**Advisory Action
Before the Filing of an Appeal Brief**

09/787,398

KRUGER, WERNER

FIG. 1

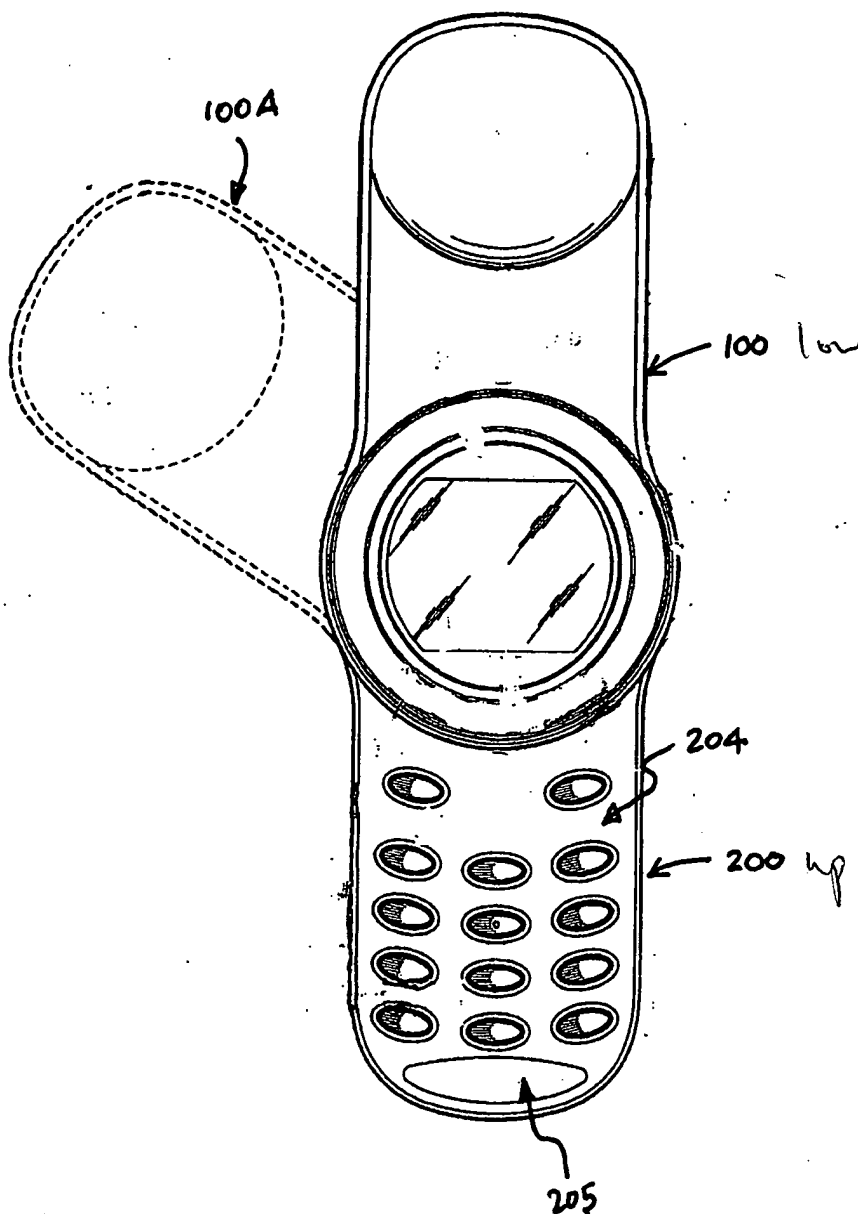
1. The amendments to the specification and the drawings filed 10/11/05 will not be entered for the following reasons. First, in the Brief Description of the Drawings, it states that Figs. 3-4 are exemplary embodiment(s). Noted that there is only one embodiment (figs. 1-2), but figs. 1-2 are in two different (open and closed) stages. It is unclear whether Figs. 3-4 intend to describe fig. 1 or fig. 2, because upper shell and lower shell are in different positions in fig. 1 and 2, it is difficult to see that fig. 4 itself can be used to achieve the functions in both figs. 1-2 according to all the functions described in the specification.

Not
Entered
J.

NOT
Entered
X

FIG 3

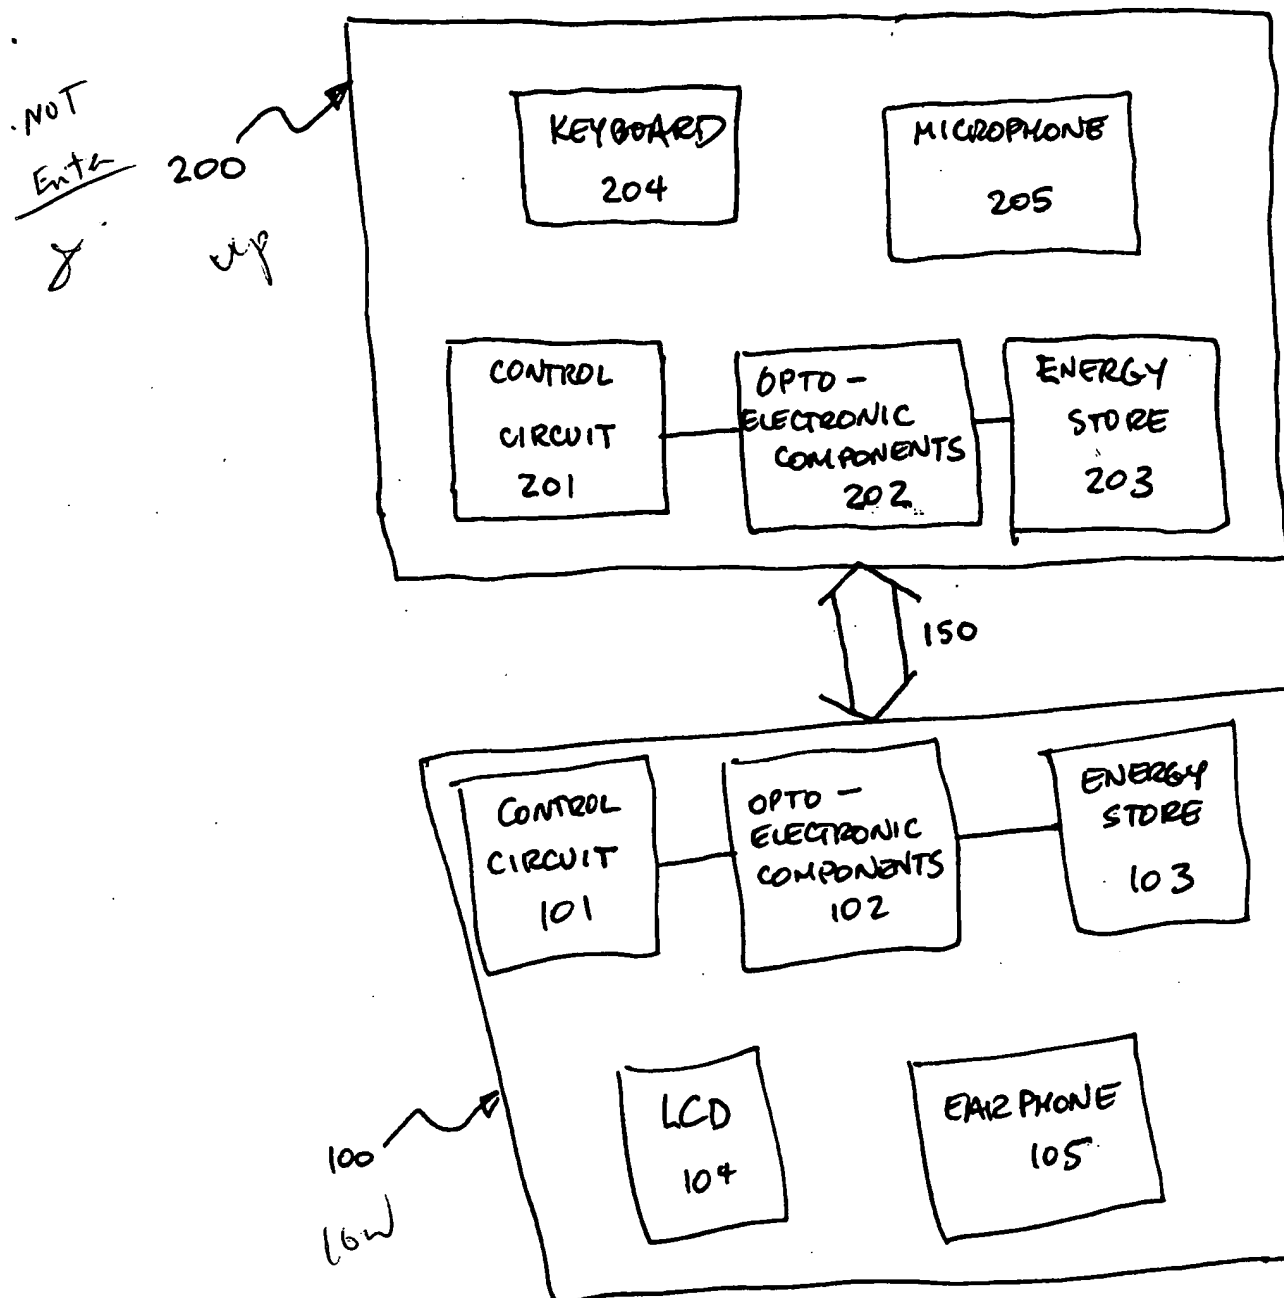
Further, in page 3, line 4, fig. 3, element (bus) 150, page 4, lines 9-10, first, it shows an electrical bus 150 connecting the upper and lower shells (100, 200), then it states that the upper shell 100 and lower shell 200 are not electrically connected to one another. In conclusion, the statements are contradicting each other and may be a new matter too.

N.T
Enter
J
